ADDENDUM	NO.	THREE
-----------------	-----	--------------

Pubic Market Renovation and Expansion

10064

Addendum 3 August 17, 2015

DOOR & DOOR FRAME ELEVATIONS SCALE: 1/4"=1'-0"

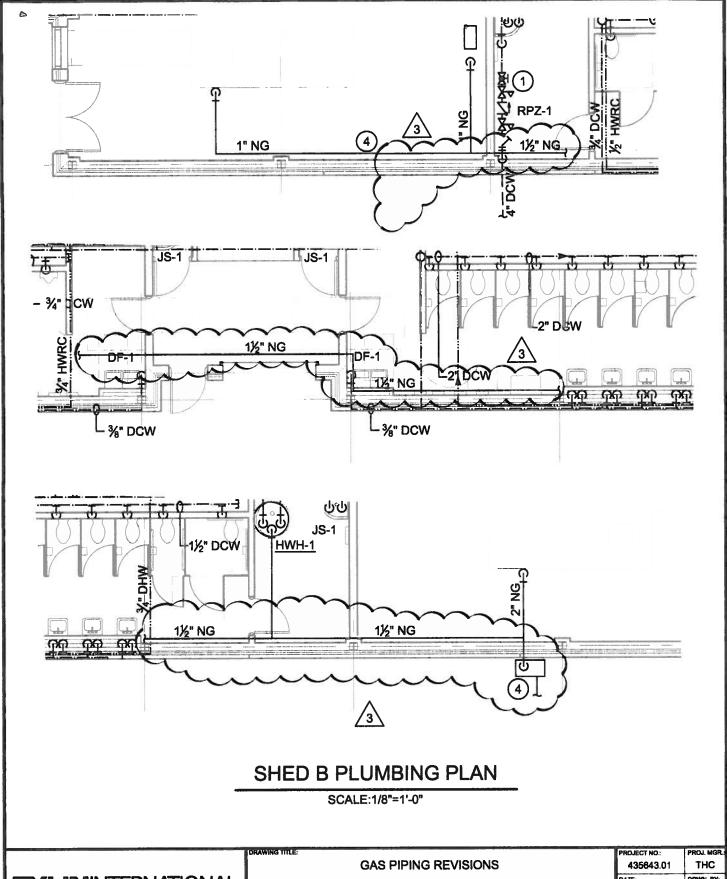
4.	DA 201	To the Door Schedule, in the Notes for Shed D Slider, revise quantity to 24, revise Hardware set for Door 001A to be #15, Door 001A to be frame HM4 and door HMD per Drawing SK-A01. Required quantity for Door 001A is 4.

TY'LIN INTERNATIONAL DRWN. BY: DATE: PROJECT NAME 8.13.15 HAJ **ROCHESTER PUBLIC MARKET** SCALE: CHKD. BY: AS SHOWN **JBF** 255 EAST AVENUE CLIENT: ROCHESTER, NY 14604 ROCHESTER PUBLIC MARKET (585) 512-2000 SK-P01 30 CHURCH STREET ROCHESTER, NY 14814

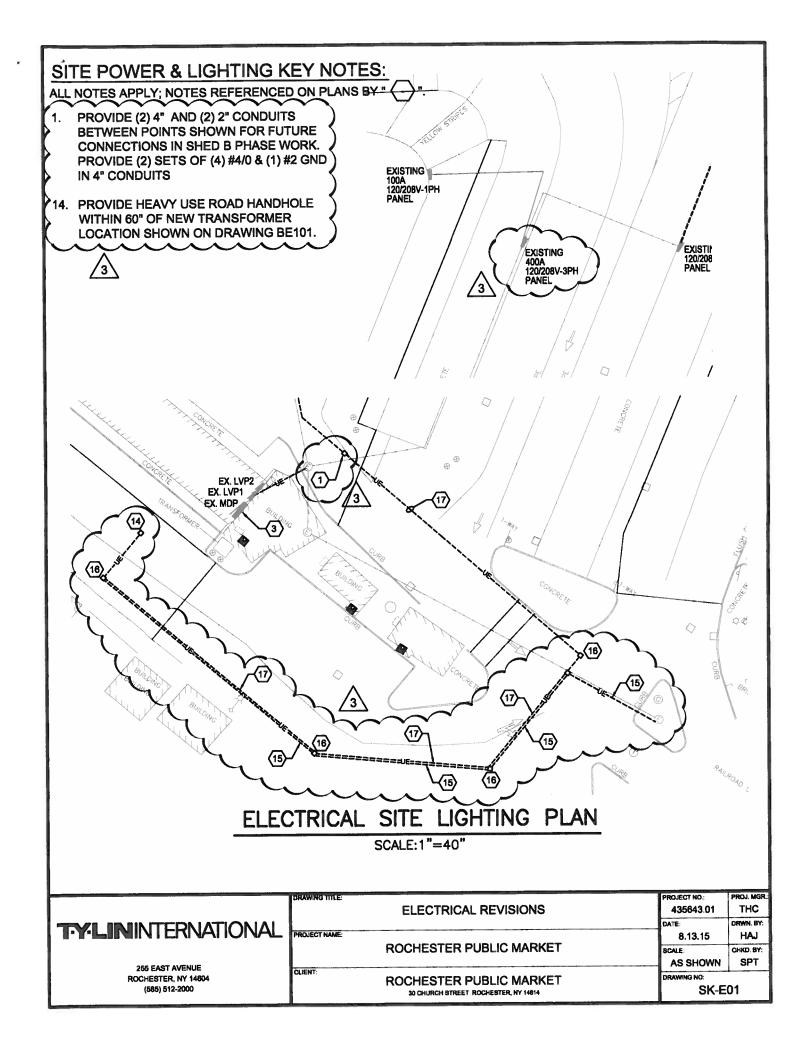
8.	BE 503	To One Line Diagram revise per drawing SK-E04
9.	BS 501	To Detail 4, revise foundation wall insulation to read: "Rigid Insulation Board R10"
10.	BP 111	To Shed B Plumbing Plan, revise per drawing SK-P01

ELECTRICAL SITE LIGHTING PLAN

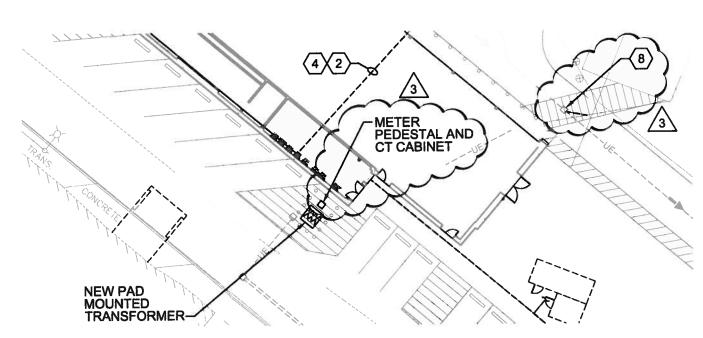
5.	DE 101	To Electrical Site Lighting Plan revise per drawing SK-E01
6.	BE 101	To Electrical Site Lighting Plan revise per drawing SK-E02
7.	BE 501	To Panel Schedule MDP-1 revise per drawing SK-E03

8. WHEN MANHOLE IS REMOVED, RE-ROUTE SHED A CONDUIT TO HAND HOLE. CONNECT SHED A FEEDERS TO CONDUCTORS INSTALLED PER DE101 KEY NOTE 1.
